**Service Bulletin:** SB EC145-702; Eurocopter EC145 Air Conditioner Condenser Upgrade.

**Subject:** Up-grade of existing condenser installation, Aircraft S/N 9089.

**Date:** 30, November 2006, Rev N/C

**Figure 1-1**

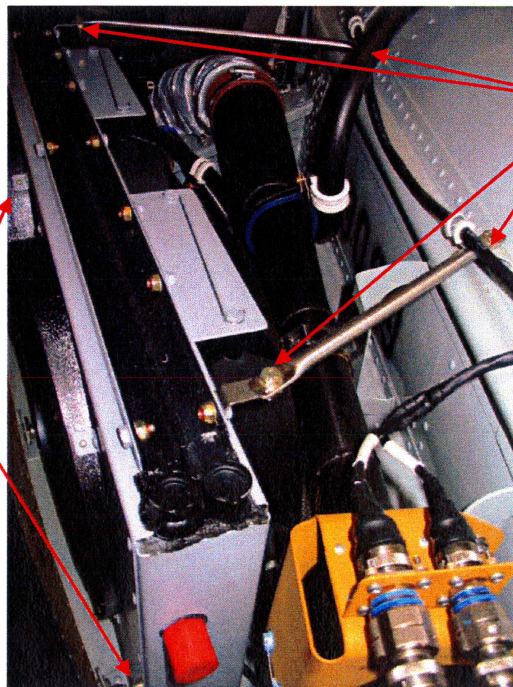
1. Discharge / Recover refrigerant form the air conditioner system.
2. Disconnect the Molex connector to the EC145-7000-1 Condenser Blowers.
3. Remove the EC145-7000-1 Condenser Assy., EC145-7010-14 & EC145-7010-22 Supports from the tail boom connecting points and the top of the condenser assembly. See Figure 1-1.

Remove the EC145-7000-1 Condenser assembly from the aircraft, by removing the existing Bolts, Nuts, and Washers from the condenser support brackets at the base of the condenser assembly.

Remove and discard the attaching hardware, and supports.

**Figure 1-2**

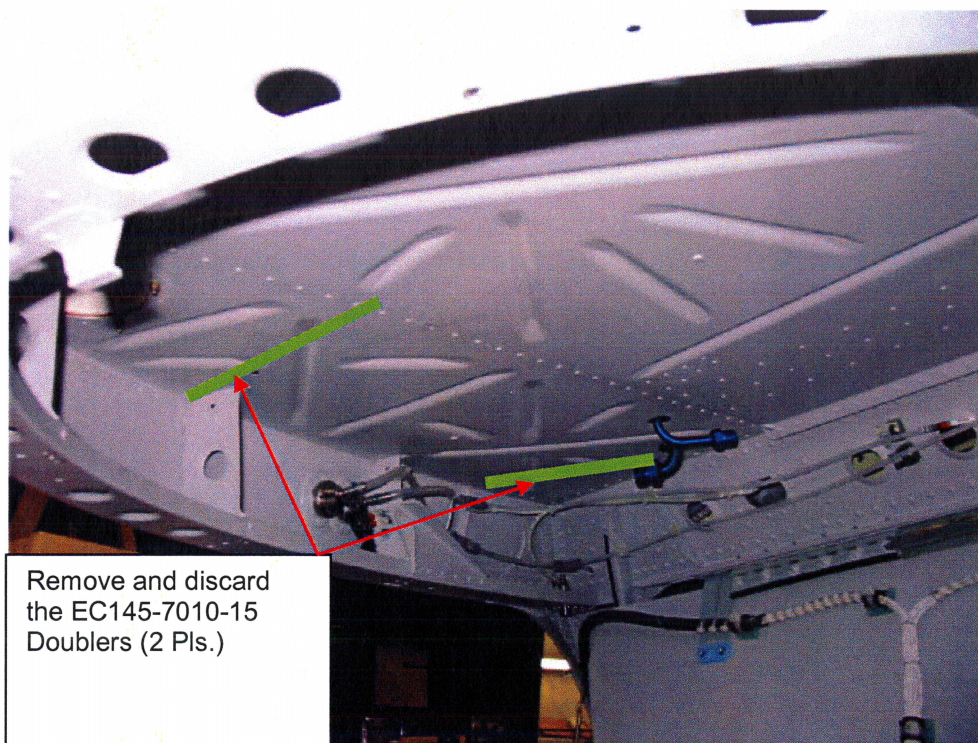
4. Remove, and discard the EC145-7010-15 Doubler (2 Pls.) mounted to the deck below the air conditioner condenser. See figure 1-2.
